FRANCIS E. WALTER DAM

DAM, OUTLET WORKS & SPILLWAY
PERIODIC INSPECTION REPORT NO. 3

NADEN-TF (3 Jun 77) 1st Ind
SUBJECT: Francis E. Walter Periodic Inspection Report Number 3

1. Subject periodic inspection report is approved subject to the following comments:

PLATE 1

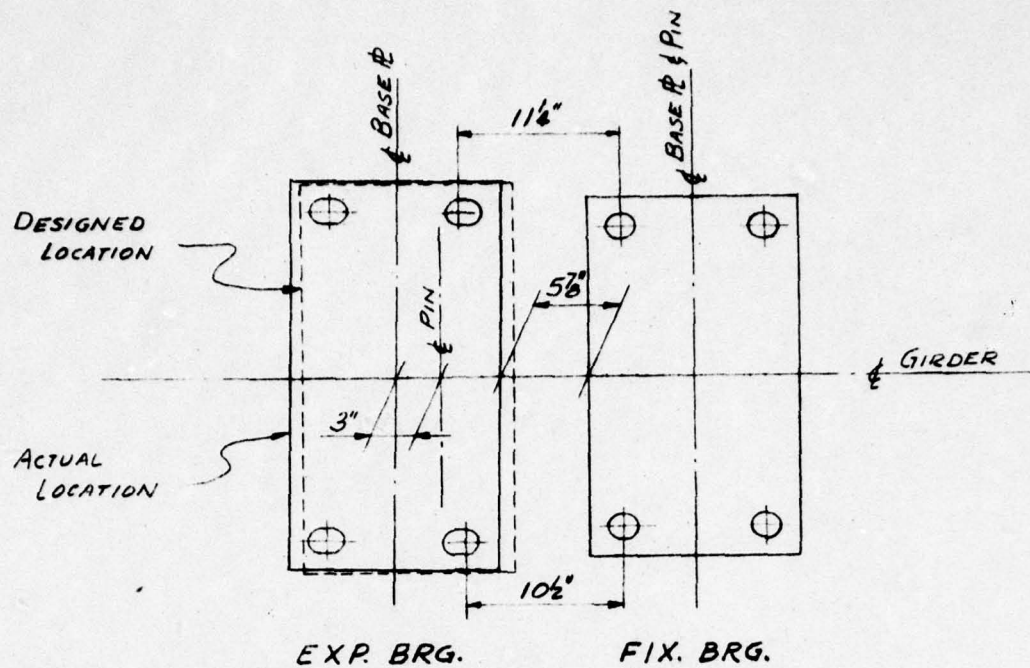
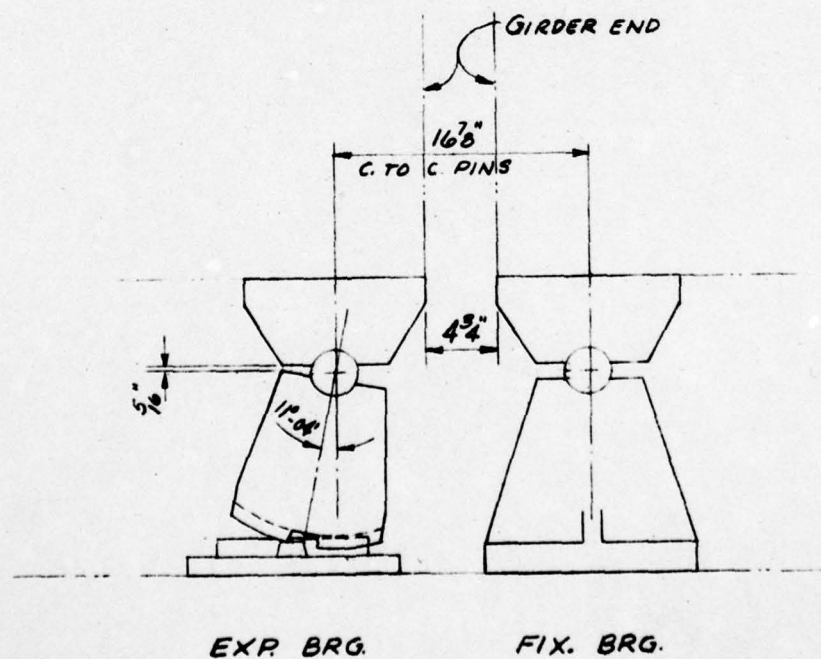
Measurements of the expansion bearing base plates relative to the fixed bearing base plates on Pier No. 2 show an average distance of 6 inches between plates. See Plates 1 and 2. The contract drawings indicate the setting distance should have been 5 inches.

a. Corrective Measures. As a result of this investigation, it is concluded that remedial action is not necessary at this time and that the structure may be used to its full design load capacity without harmful stress overloads. However, it is recommended that funds be programmed to correct the condition.

Several methods of alleviating the problem are suggested. Probably the simplest approach would be to jack the expansion ends of the girders off the base plates, permitting the rockers to hang vertically. The interfering teeth would then be removed by cutting torch and/or grinding and new teeth would be welded into proper position to engage the rocker notches. A variation of this method would be to simply remove the interfering portion of the teeth thereby allowing the rockers to rotate freely in the contracting direction.

PIER NO. 2 - EAST SIDE
EXPANSION BEARING (LEFT) SEEN FROM INSIDE GIRDER
PHOTO #1

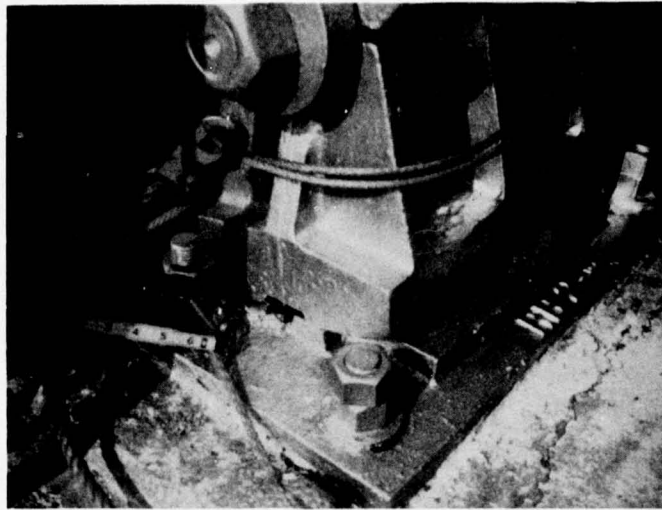
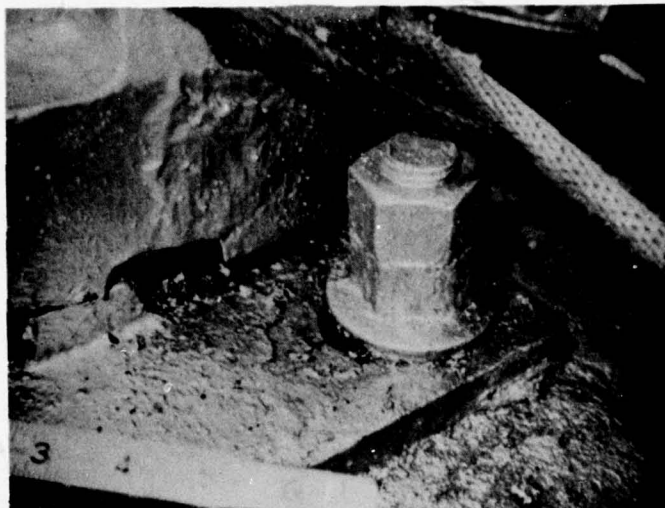
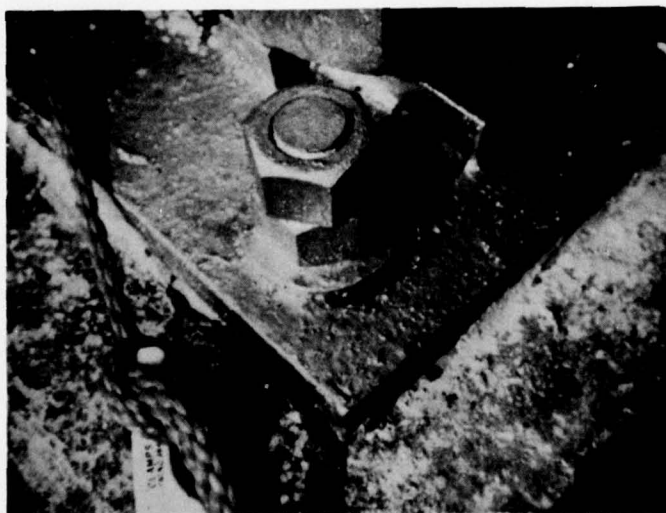
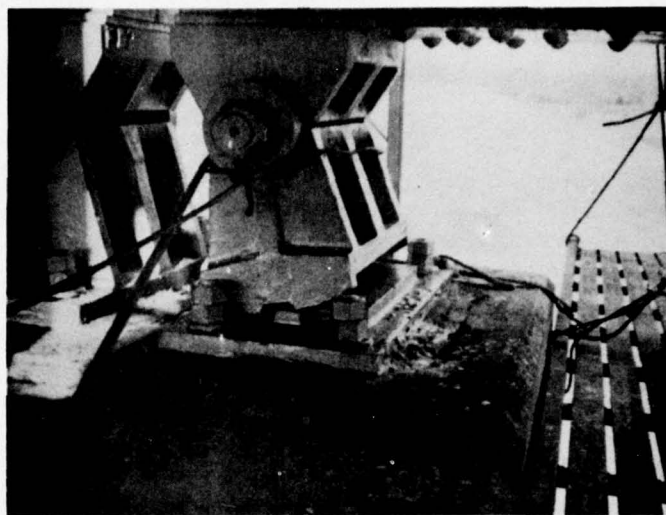
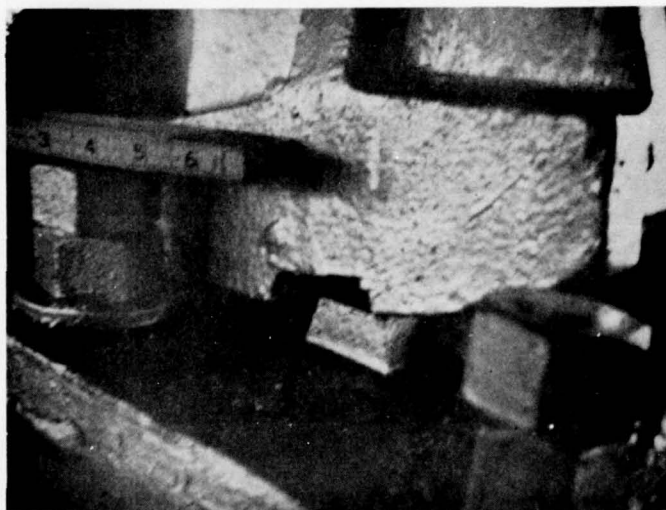
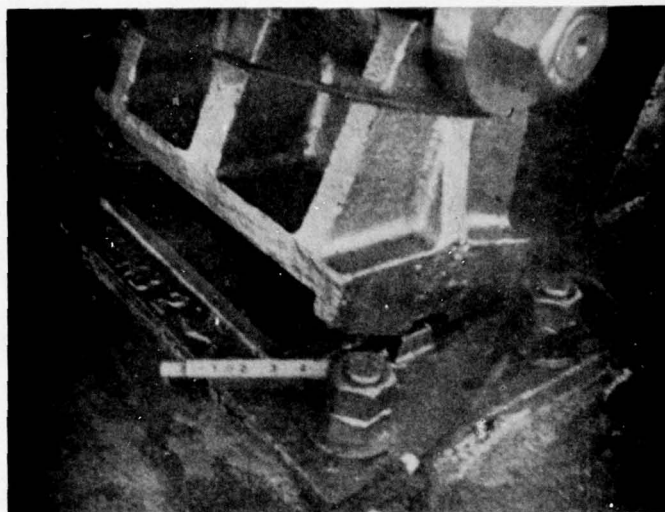
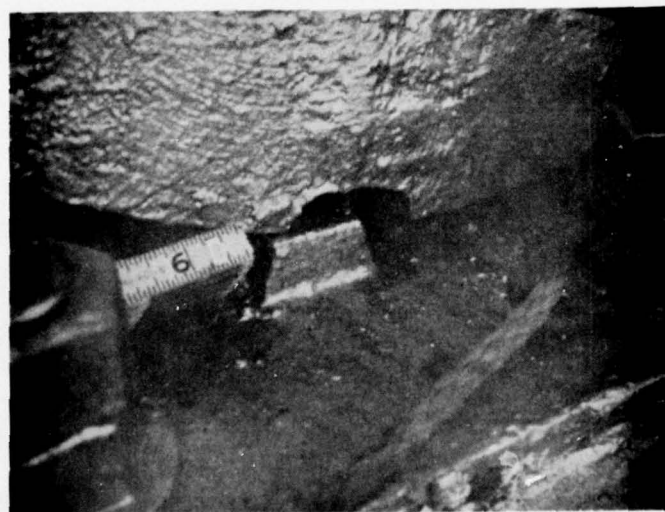
PIER NO. 2 - EAST SIDE
CLOSE-UP OF ABOVE SHOWING DISENGAGEMENT OF ROCKER
AND BASE PLATE
PHOTO # 2

PIER NO. 2-EAST SIDE
CLOSE-UP OF ABOVE SHOWING DISENGAGEMENT
PHOTO # 4

PIER NO. 2-WEST SIDE
CLOSE-UP OF ABOVE SHOWING DISENGAGEMENT OF ROCKER
AND BASE PLATE
PHOTO #8

PIER NO. 2-WEST SIDE
CLOSE-UP OF ABOVE SHOWING DISENGAGEMENT
PHOTO # 10

a. While the misalignment of the expansion rockers on the access bridge does not endanger the structure at present, a project should be initiated to correct this condition and allow the rockers to function normally.
